Olympus Reference: QIL FY26-EMEA-14-FY26-903-F KD-645L & KD-640L

URGENT FIELD SAFETY NOTICE

RE: Triangle Tip Knife J – Single Use Electrosurgical Knives

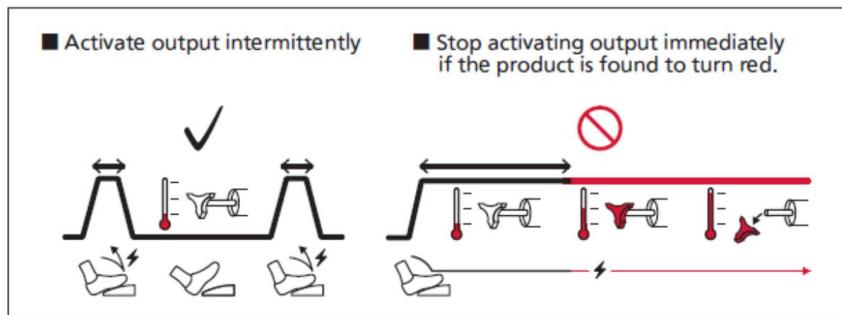
Olympus is also notifying users of the following updates to the Instructions for Use and labeling:

- Addition of the following **visual aid** to more clearly communicate these instructions to users.
